March 20, 2001

Re: Final Conditional Approval of General Electric's September 2000 revision of the Baseline Monitoring Proposal for Plant Site 1 Groundwater Management Area, General Electric (GE) Housatonic River Project Site, Pittsfield, Massachusetts.

FIGURE 1
GMA-1
MONITORING WELL LOCATIONS

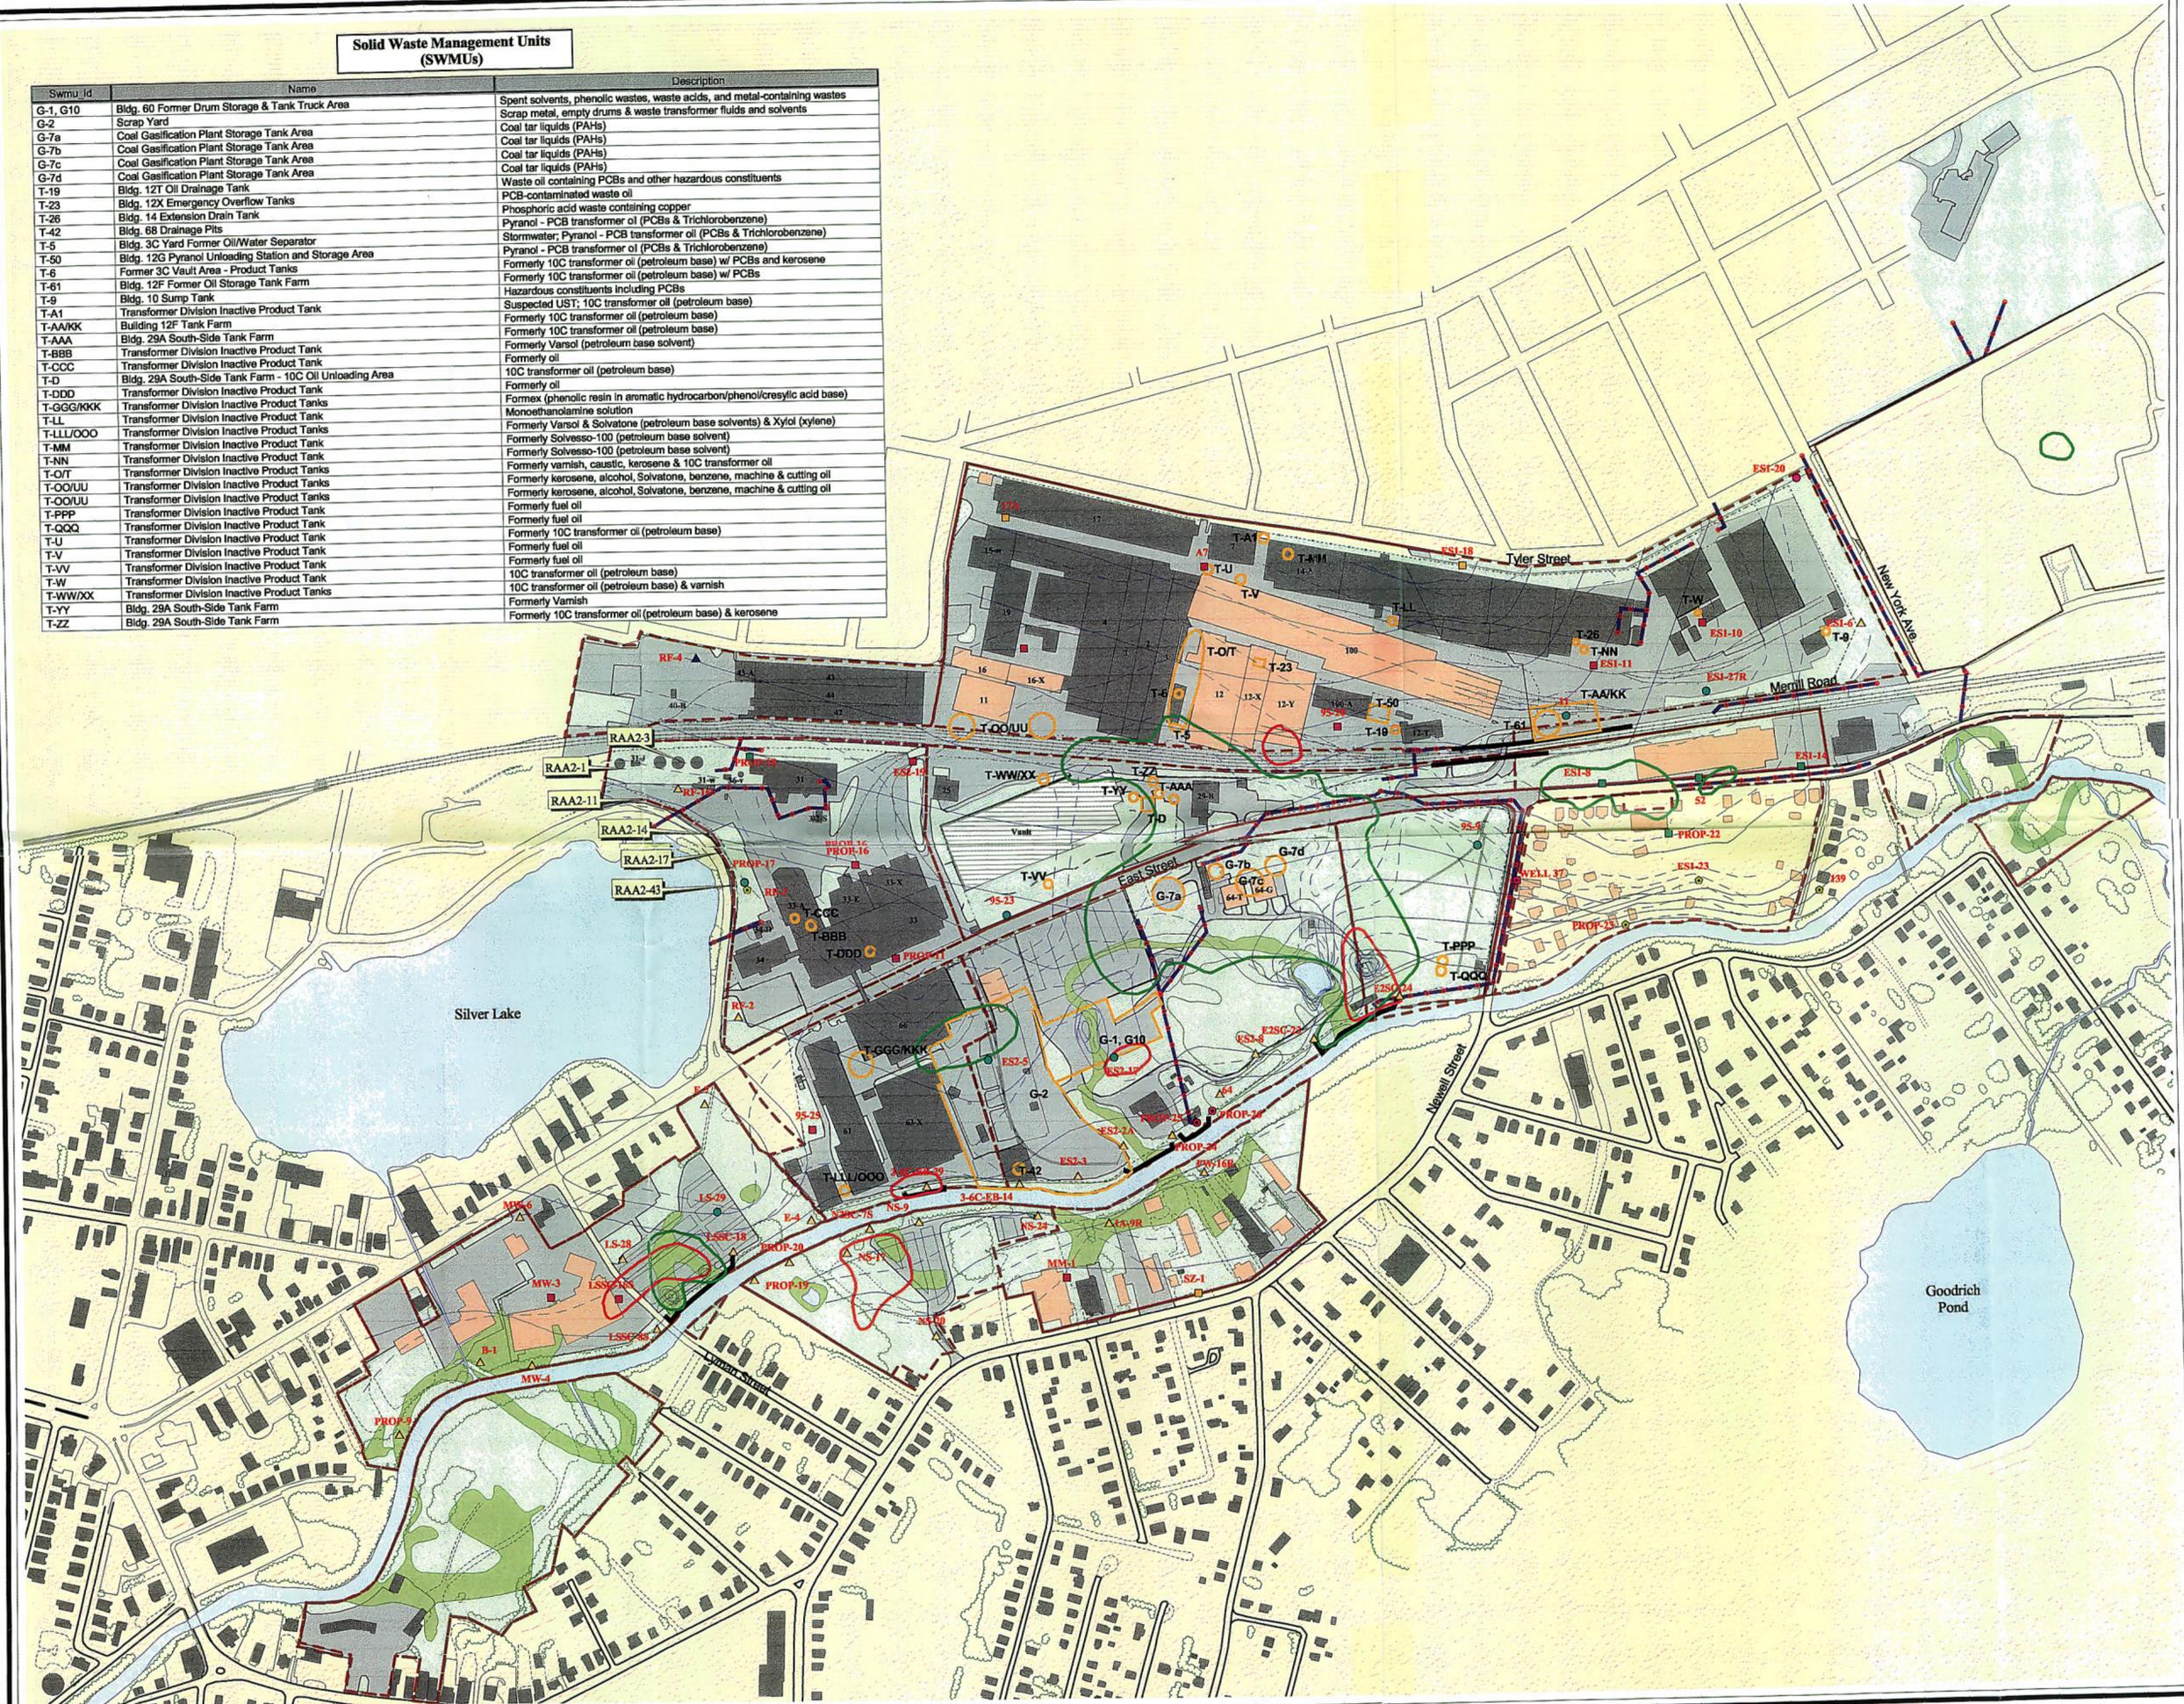
1. The final list of GMA-1 baseline monitoring wells should include any additional wells needed to monitor conditions along the riverbanks related at future NAPL discoveries, which may occur during the continued Removal Action in the upper 1/2-Mile Reach. To the extent that additional NAPL is discovered in the future, GE shall evaluate the need for such additional wells and, and submit its evaluation, and if appropriate, a proposal for installation of such wells to EPA for review and approval.

3. GE shall monitor well PROP-24 (HR-G1-MW3) associated with the Cell G1 containment barrier as GW-3 perimeter location in GMA-1. In addition to the GW-3 monitoring, GE shall add all three of the wells associated with the Cell G1 containment barrier (PROP-24, -25, and -26) to the GMA-1 NAPL monitoring program. EPA approves the change from weekly to monthly NAPL monitoring at the three wells, as proposed by GE in their March 9, 2001 letter to EPA.

4. Since GE has not proposed groundwater extraction/hydraulic controls at Cells G1, G2 and G3, additional groundwater level monitoring shall be required to evaluate potential groundwater mounding behind the sheetpile containment barriers and changes in the area groundwater flow patterns. GE shall monitor, at a minimum, three wells for each new sheetpile containment barrier: one at each end and one in the middle. GE shall conduct such groundwater level monitoring at the wells associated with Cell G 1 on the same monthly schedule approved for NAPL monitoring at these wells. For the wells associated with Cells G2 and G3, GE will propose a schedule for the groundwater level monitoring on a case-by-case basis for review and approval by EPA.
